Planning Commission Meeting

Meeting Date: Tuesday, March 19, 2019

5.3. 18-047 DR/VAR/ADJ Sandy Vault Self Storage 41 - 243

SANDY VAULT A SELF STORAGE FACILITY DESIGN REVIEW CHAMPION WAY, SANDY, OREGON 97055

A4

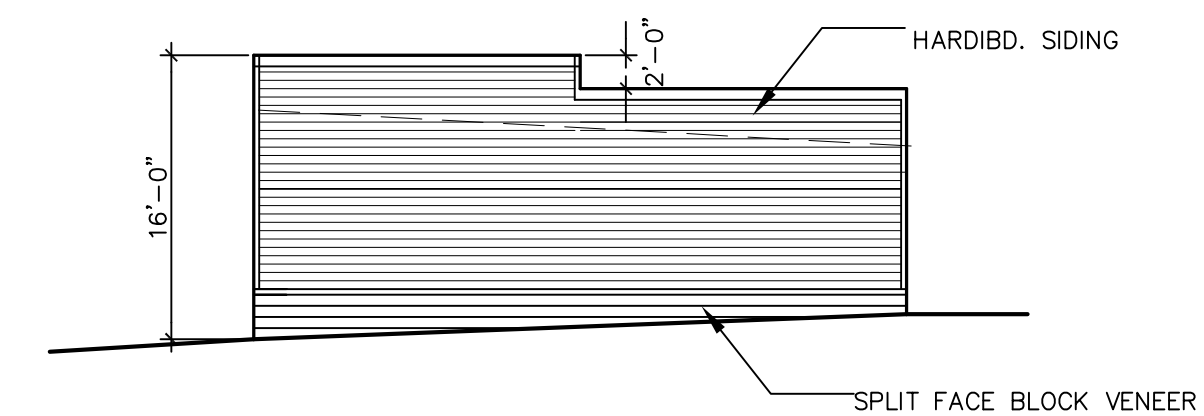
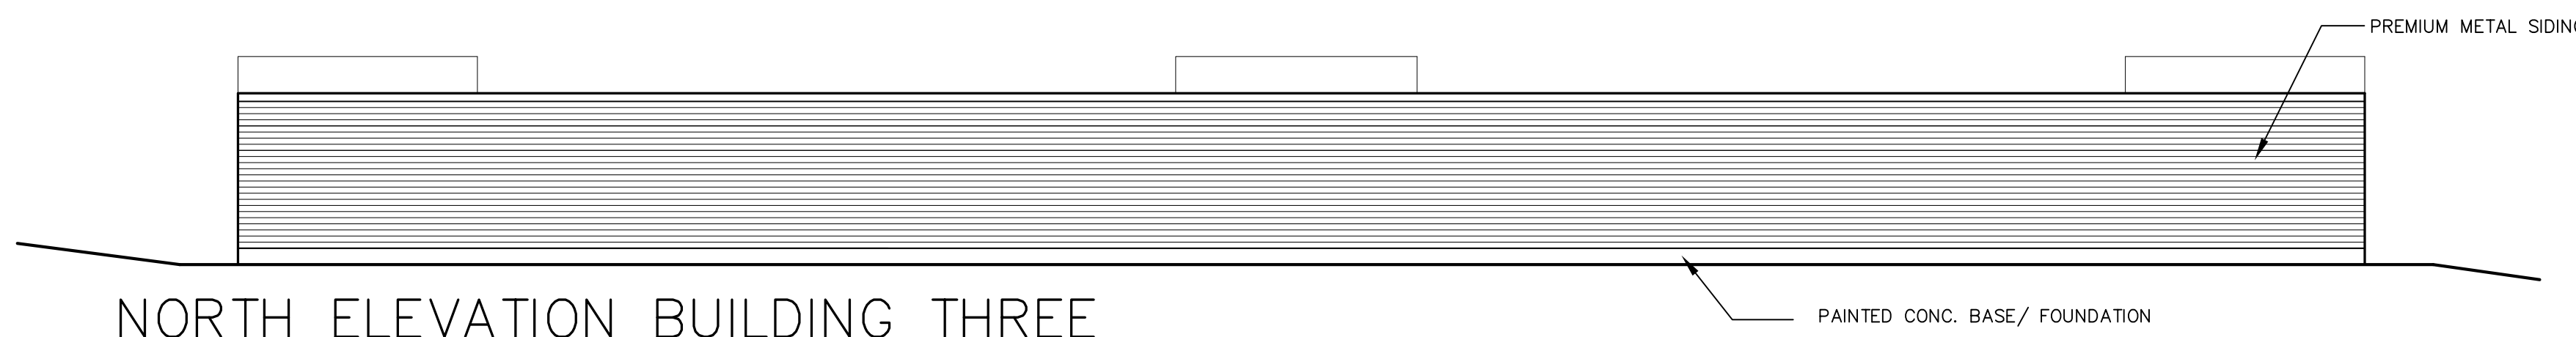
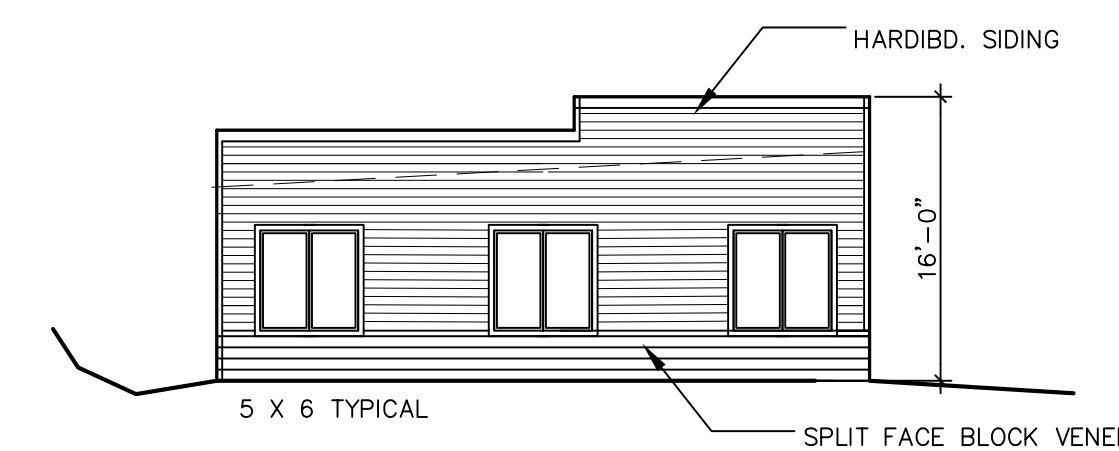
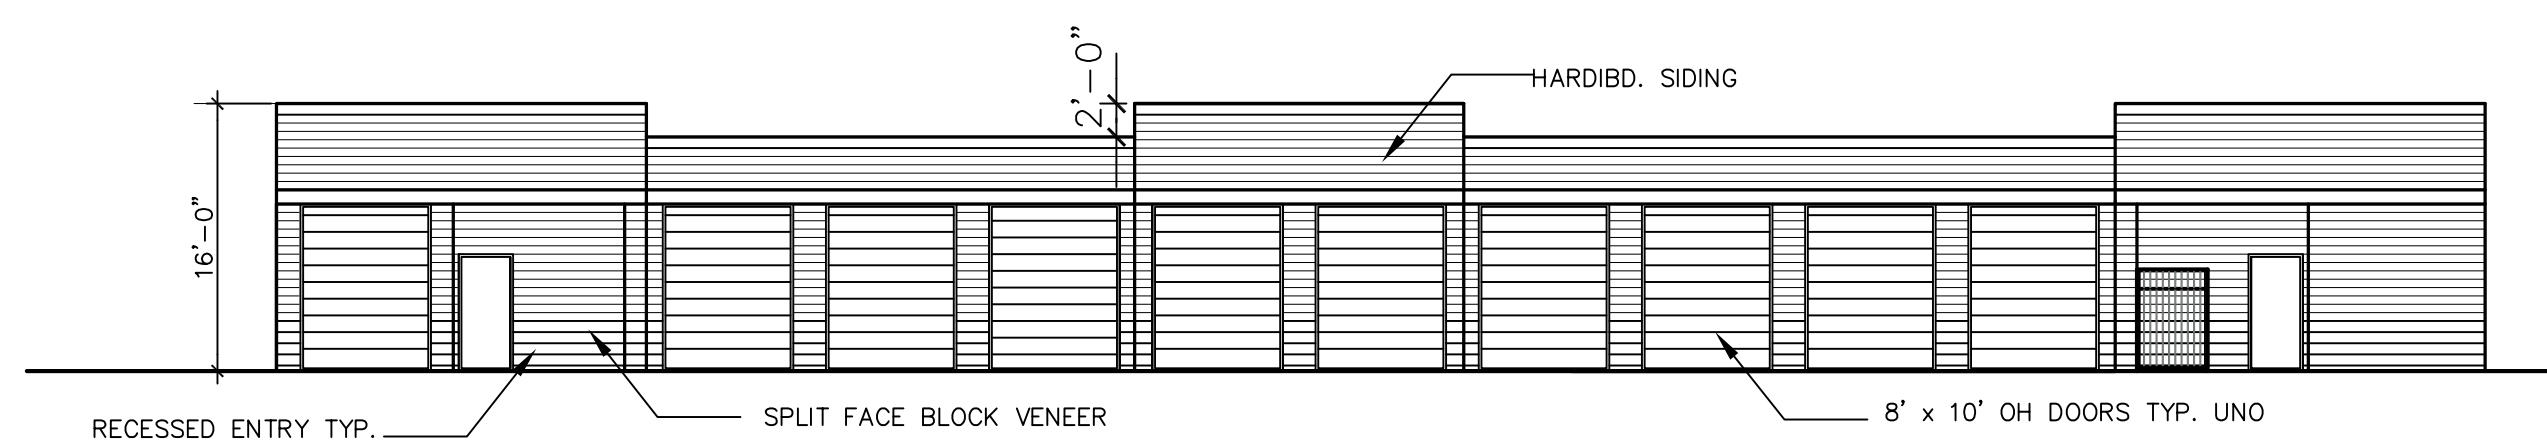
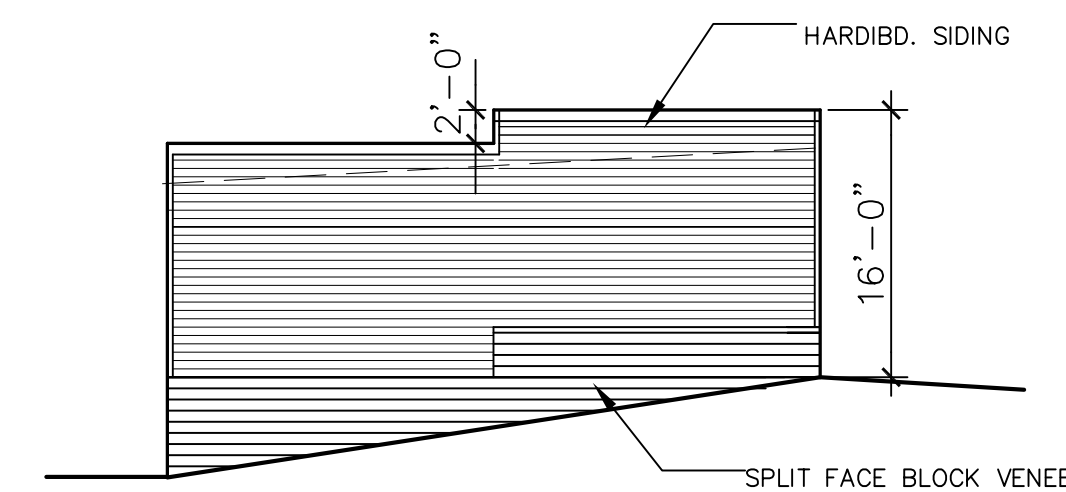
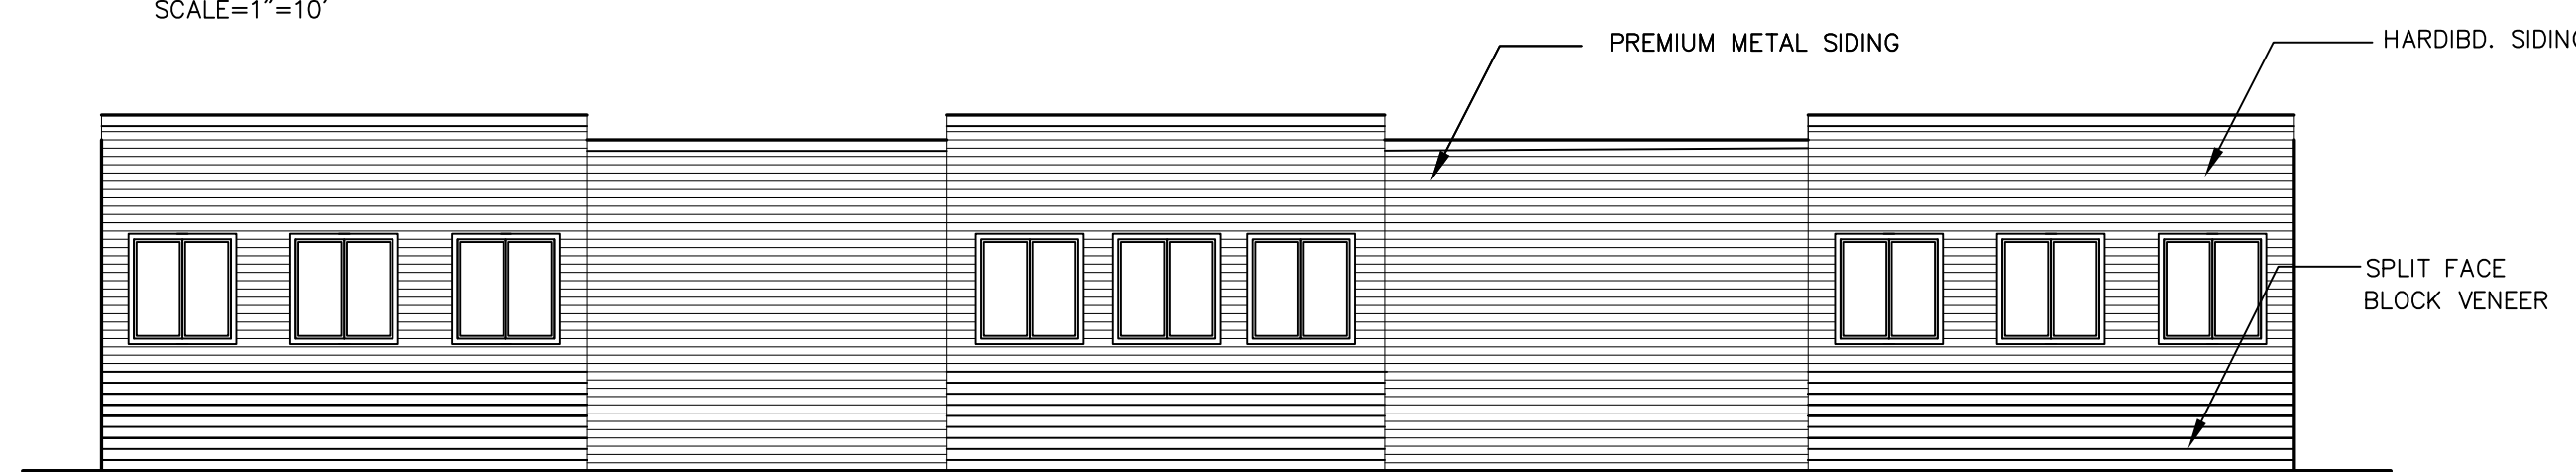
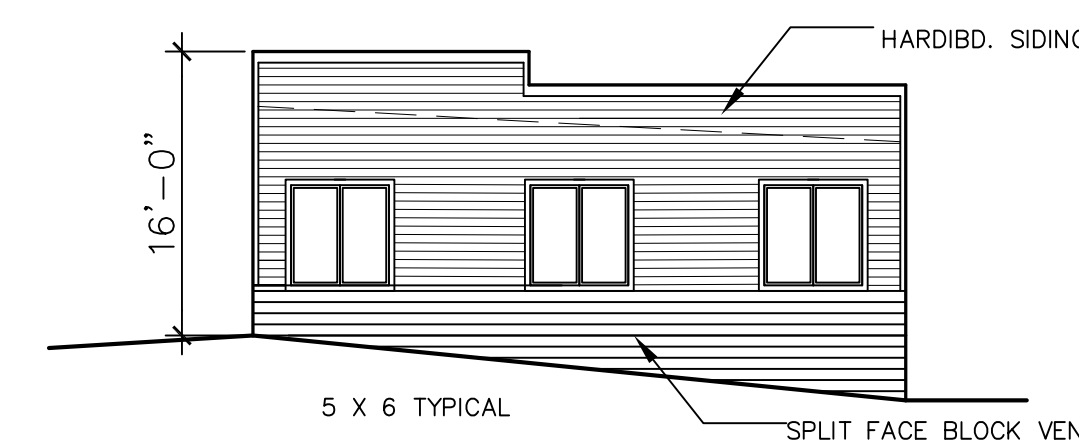
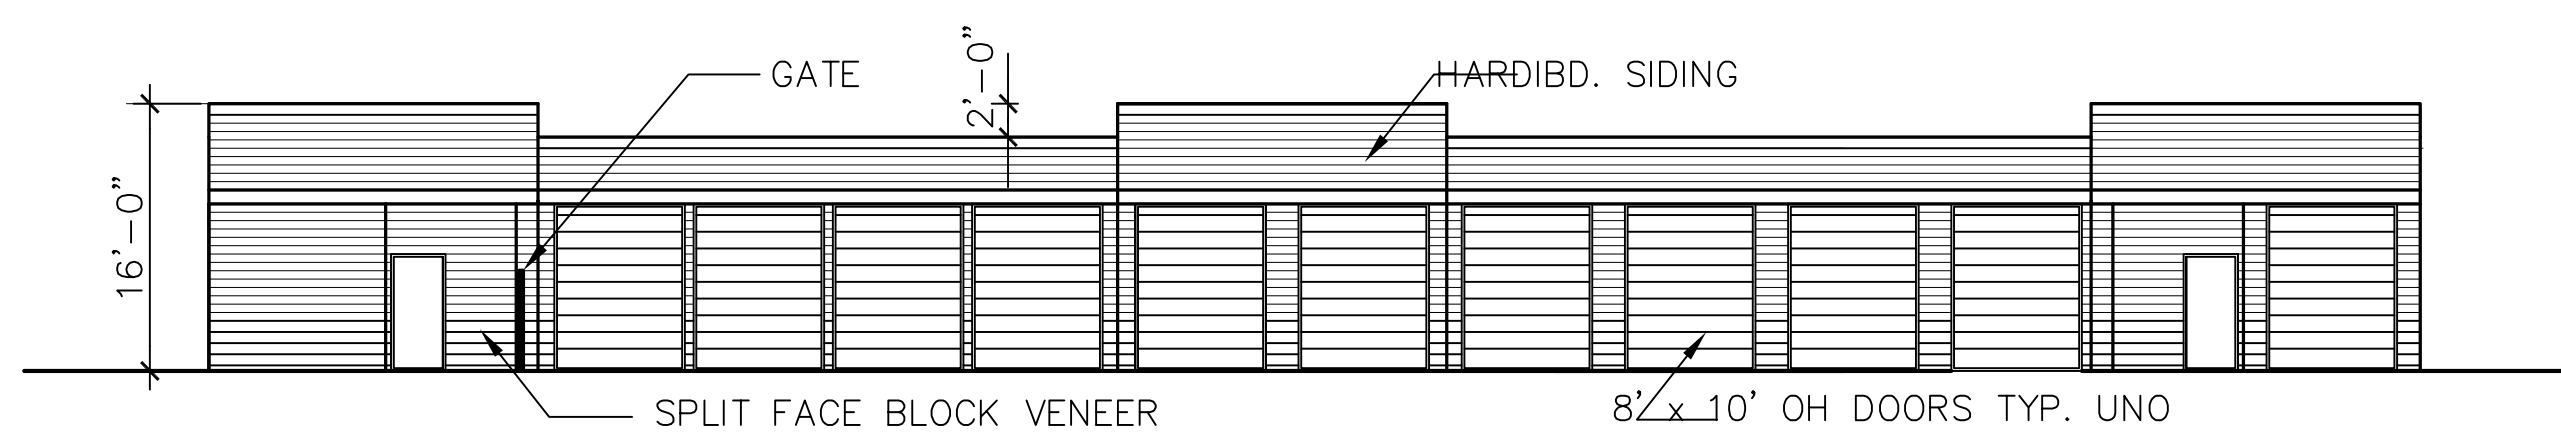
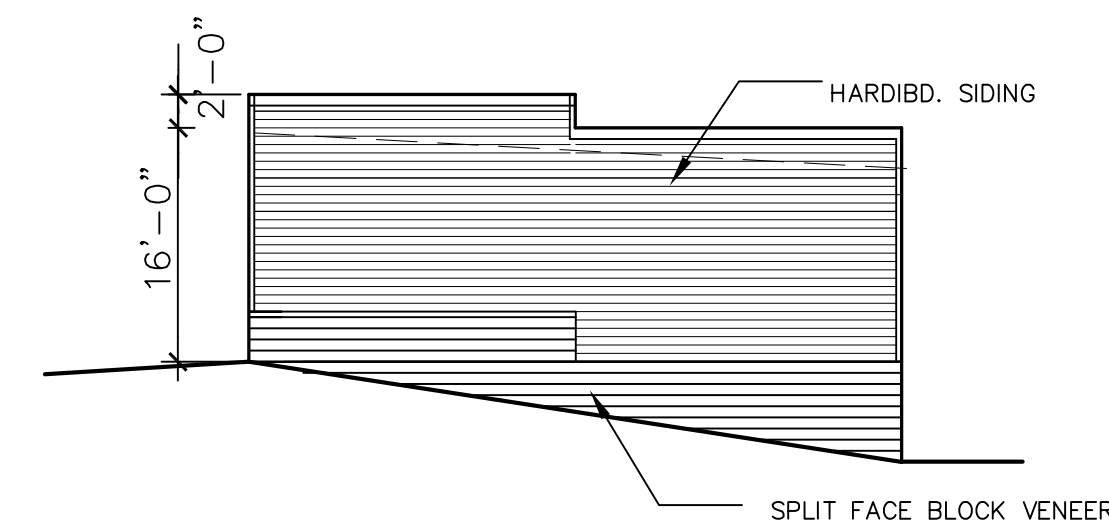
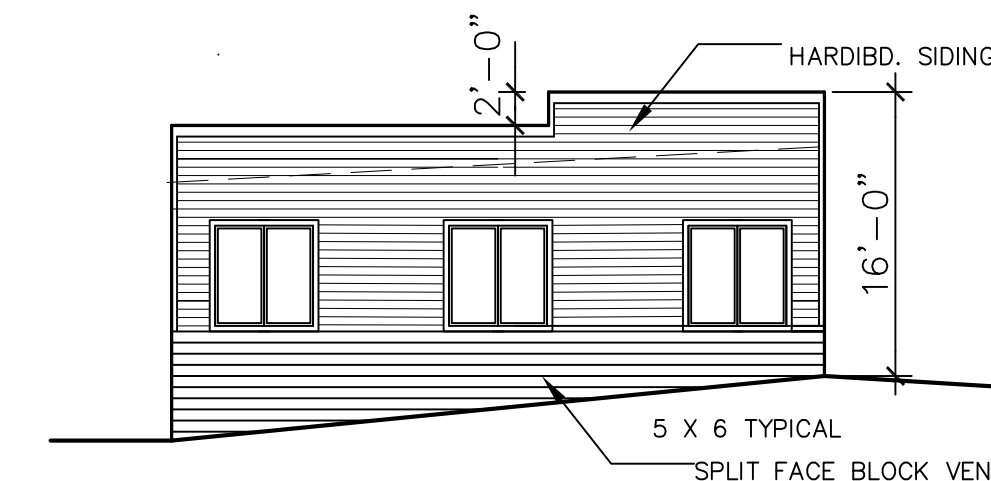
RESPONSE: *The applicant is proposing to use metal siding on Buildings 2, 3, 4, and 5 and is requesting a variance to use 36 percent metal siding (20 percent more than the 30 percent maximum allowed); however, the submitted elevations (Exhibit C, Sheet A4) detail 100 percent metal siding on some facades. The applicant's deviation, adjustment, and variance narrative (Exhibit B) states that the metal siding is visually indistinguishable from the hardie board lap siding and that it will only be used on facades that will be hidden from view by retaining walls, trees and/or other buildings. The variance request will be discussed further in Chapter 17.66 of this document.*

S:\Projects\2017\Projects\17-034_Sandy_Vault\Drawings\2_Glazing\Diagrams\17-034_A5_Glazing Diagrams 17-034.dwg © Plot Date: Dec 11 18 © Time: 3:43 PM

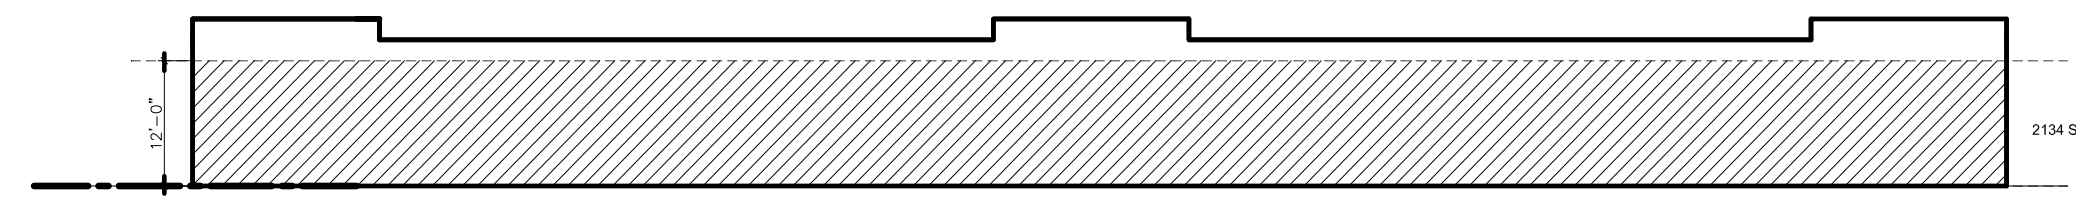
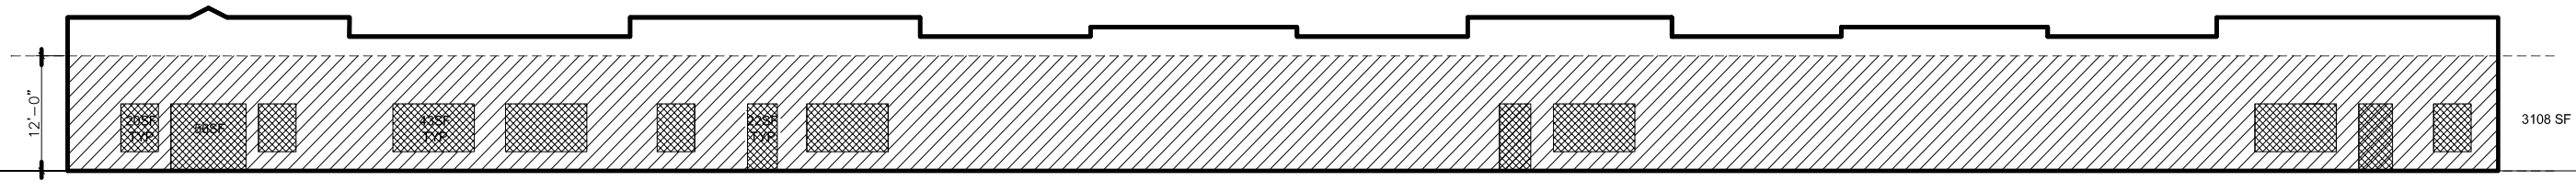
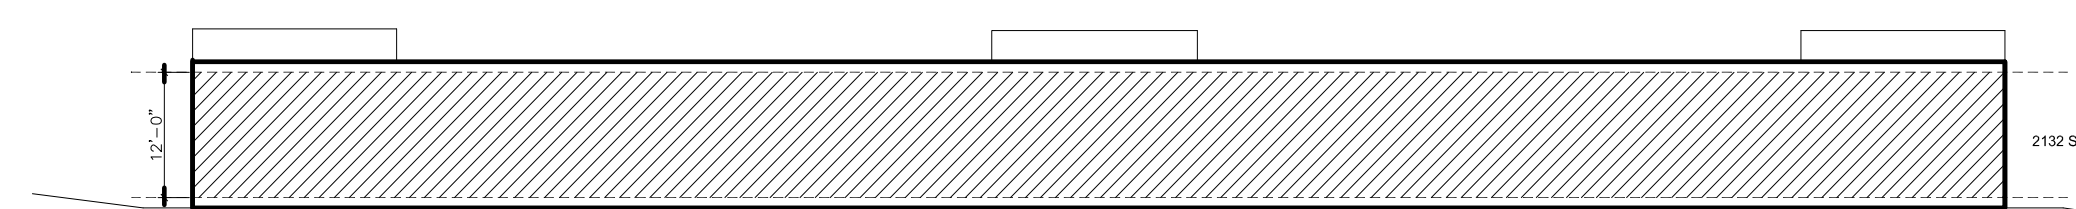
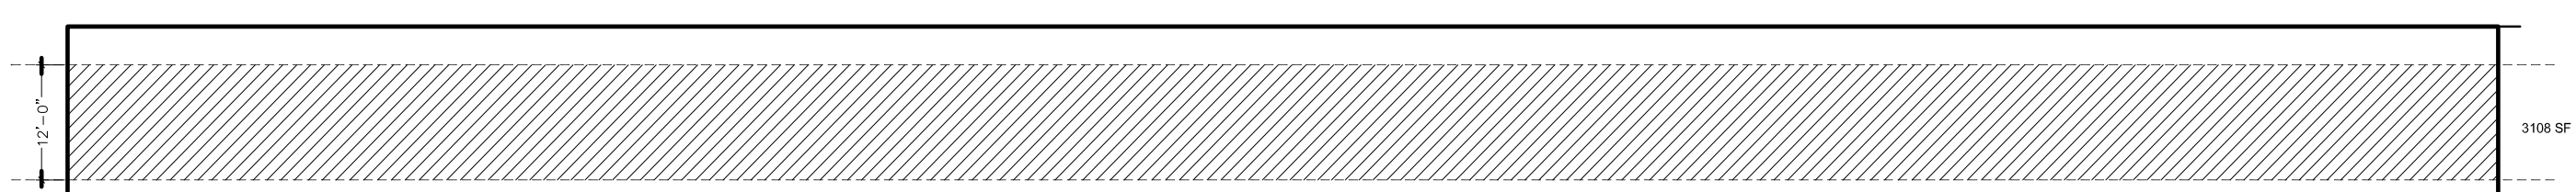
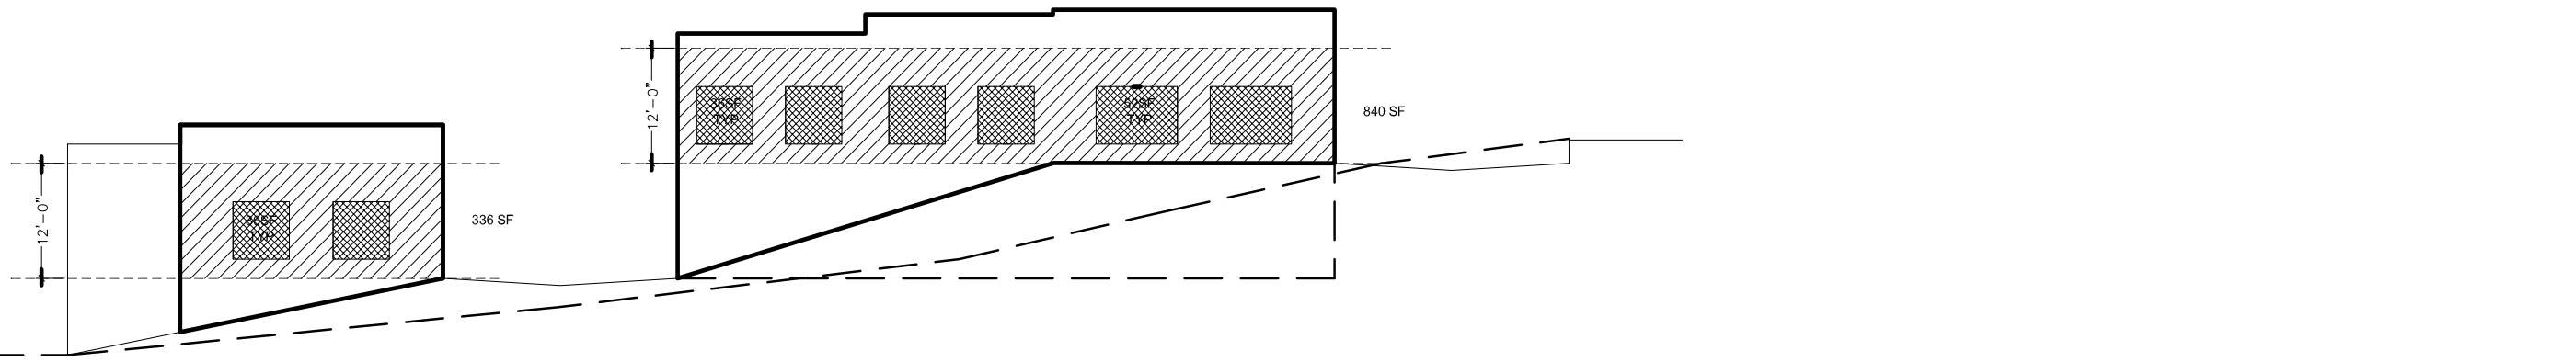
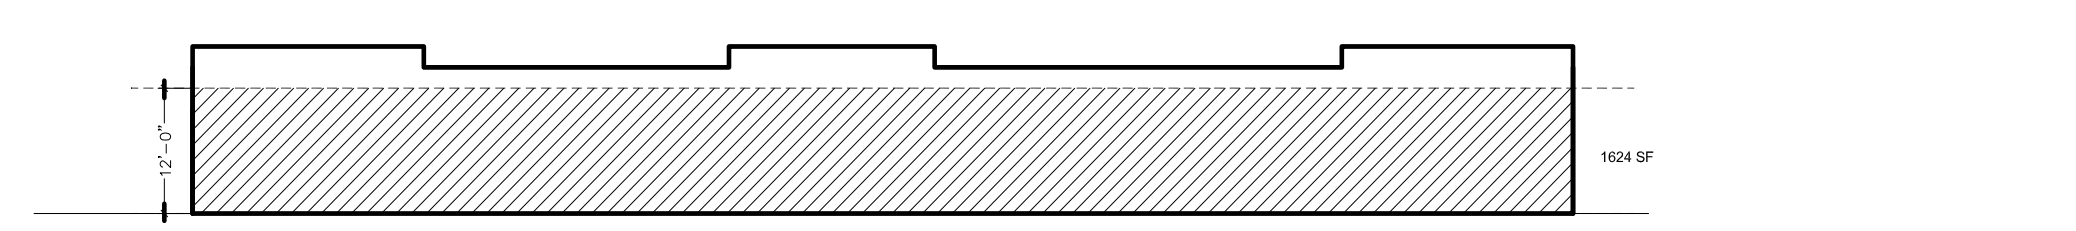
***RESPONSE:** The activated elevations of all five (5) buildings contain false windows. The applicant submitted window glazing diagrams and calculations (Exhibit C, Sheet A5) that detail proposed windows on each elevation as well as a calculation of window percent for each elevation. Only the east elevation of Building 1 meets the required window percentage. The applicant has requested a variance to the window coverage requirement for all other activated frontages. The applicant previously submitted an application for a code interpretation related to the storage project (File No. 18-027 INT, Exhibit O). During the Planning Commission hearing, the Planning Commission decided that faux or false windows could count towards the required window percentage. Thus, the applicant is not required to apply for a variance to allow the use of faux windows rather than clear glass windows as required by Section 17.90.120(E.2.a). The variance request to reduce required window percentage is discussed further in Chapter 17.66 of this document.*

RESPONSE: As indicated on Sheet A5, only one of the proposed activated facades meets the standard for glazing area. The applicant contents that the glazing proposed is consistent with the intent of the code, to the extent that it is possible for a self-storage facility. This typology is allowed by right in the I-1 zone. However, the fundamental nature of this use precludes glazing on most areas. The building is used for secure storage, and window openings for spaces that will not be occupied is impractical and poses a security risk. The applicant has proposed faux windows, where glazing is set in exterior walls and a framed wall is located behind the glass, so it does not provide access to the interior of
